SUSTAINABLE MOBILITY

FOR ARLINGTON COUNTY

February 11, 2025

RE: Barcroft Streets and Fire Code Aerial Access

Appendix C – Proposed Barcroft Street Sections

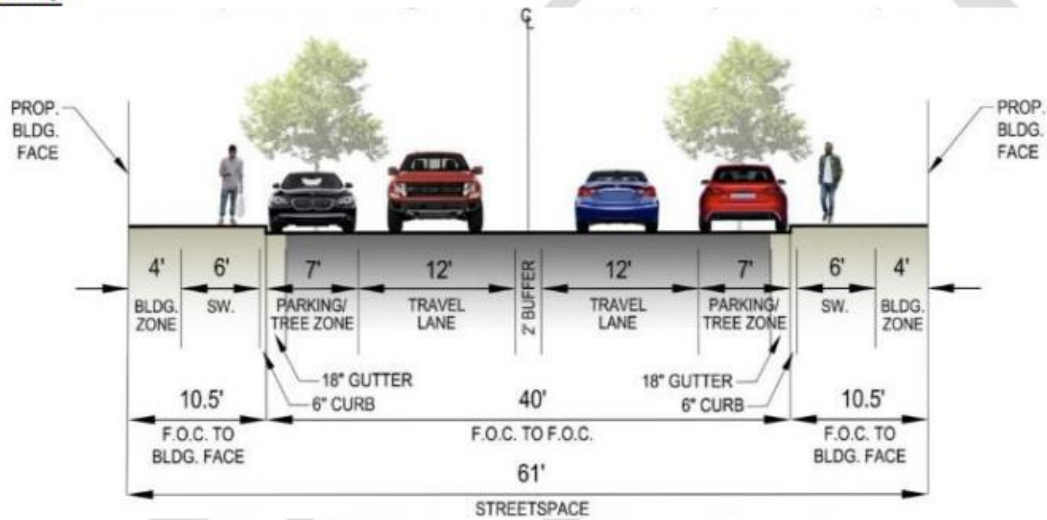
Narrow lanes save lives. Wide streets encourage speeding. These are long-understood maxims in transportation planning in Arlington County (*see Appendix A and B in this letter*). If you look at the street cross-sections labeled *ST 86-40* and *ST 61-40* in your briefing materials for Barcroft (*or Appendix C of this letter*) you will see streets that don't look like any other planning document in Arlington County. *ST 61-40* has 12' wide travel lanes. *ST 86-40* has a strange 4' painted buffer in the middle that appears to serve no purpose. These are not things we generally see in Arlington where the demands on our right of way are huge and every foot of road space is precious. The resulting wider lanes proposed here (12') will result in higher speeds and more crashes, and because the painted median or buffer reduces the "visual narrowing" effect of the 11' lanes in the other cross-section, it is likely to result in higher speeds and higher crashes as well (to say nothing of increasing impervious surfaces, the urban heat island effect, increasing pedestrian crossing distances, and stormwater runoff).

Appendix D – Arlington County Graphic Depicting Aerial Access Road Requirements

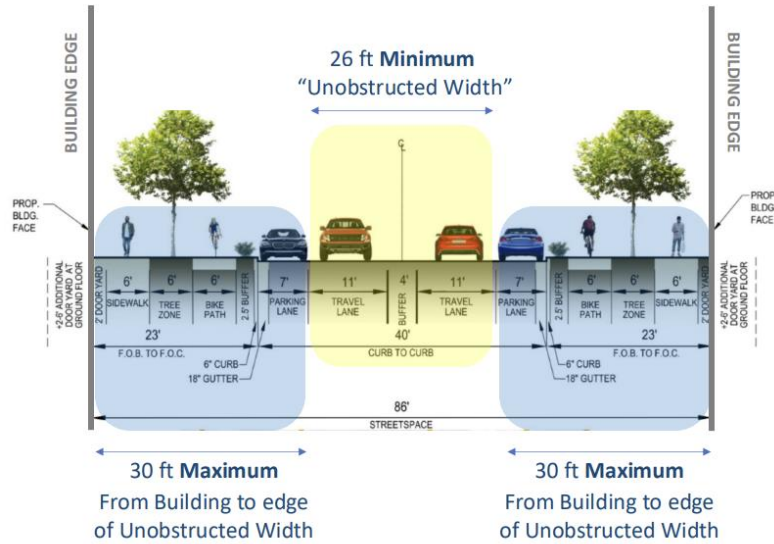
These strange cross sections are a result of the fire marshal enforcing the aerial access section of Appendix D of the Fire Code. It states that access roads (including streets) for buildings over 30' tall must have an unobstructed clear width of 26' and that the access road must be no closer than 15' and no farther than 30' from the building (*see Appendix D in this letter for an illustration*).
